Addendum No. 2

5-8-24

**Mississippi Valley State University
Rice-Totten Stadium Turf Replacement
Itta Bena, MS**

Drawing No C107
CONSTRUCTION DETAILS (1 OF 2)

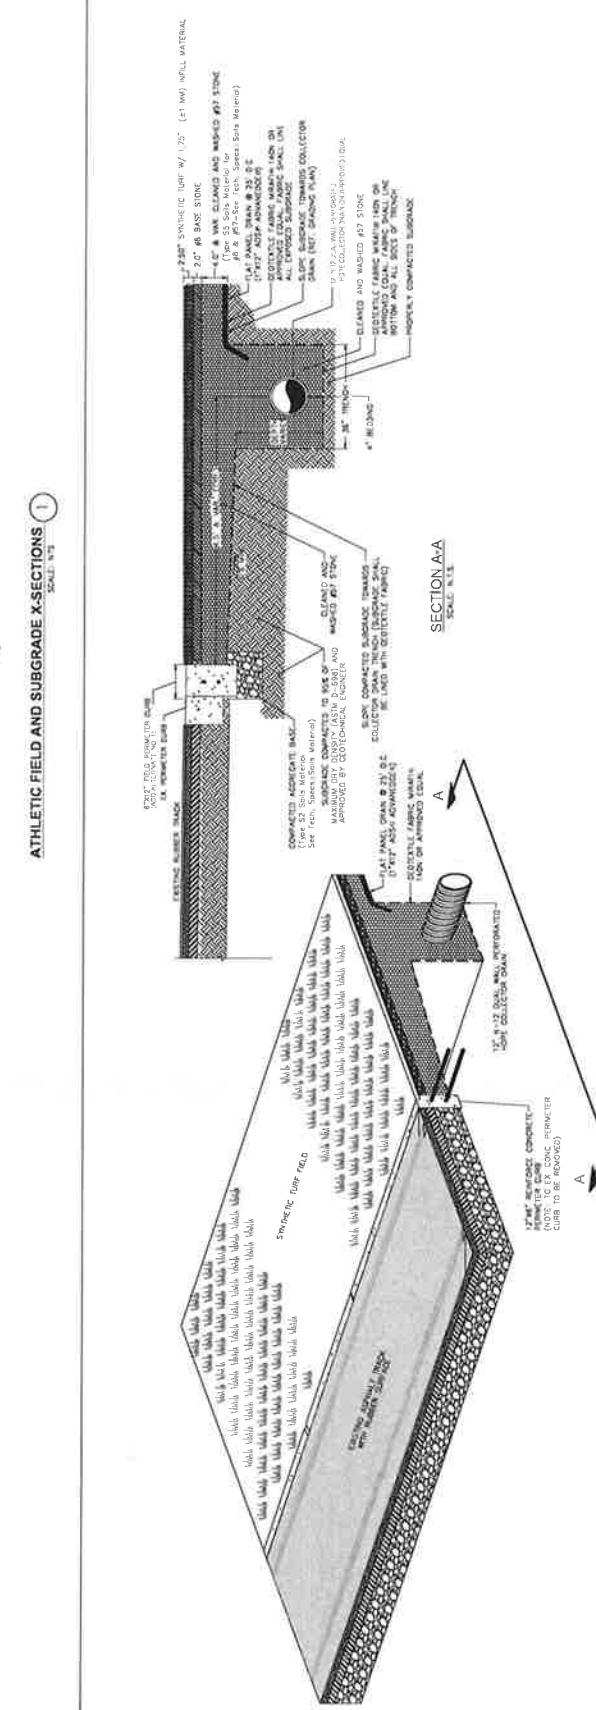
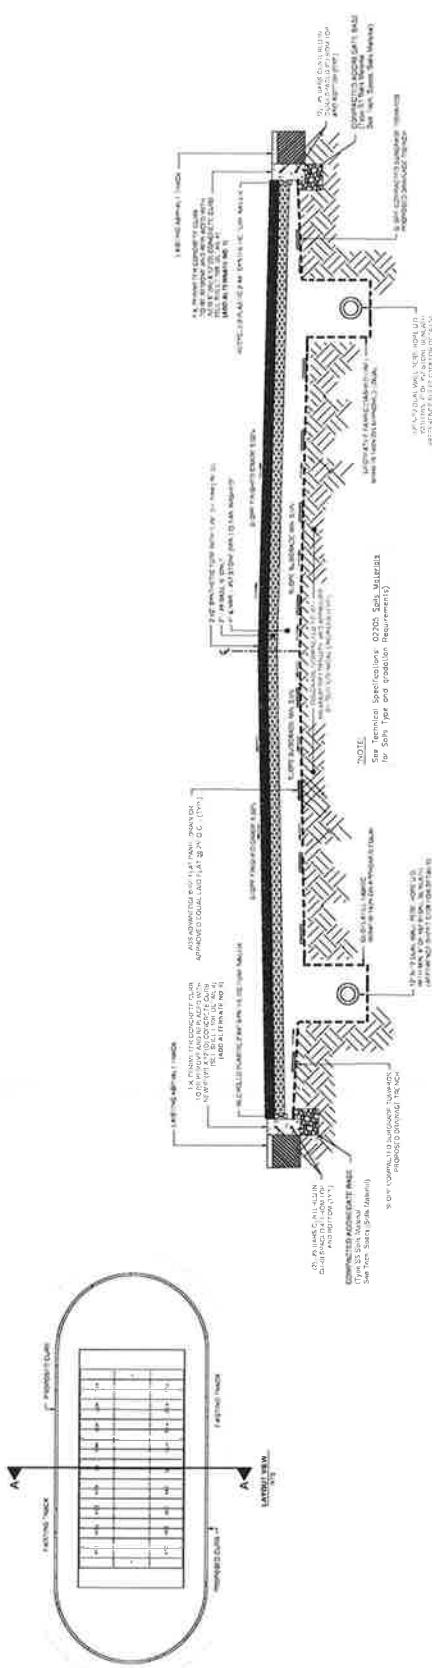
4. Which Geotextile fabric is to be used? C107 states 140N, C109 state impermeable and the Soils report refers to C180N.
Answer: The 140N geotextile fabric will be used for the project.
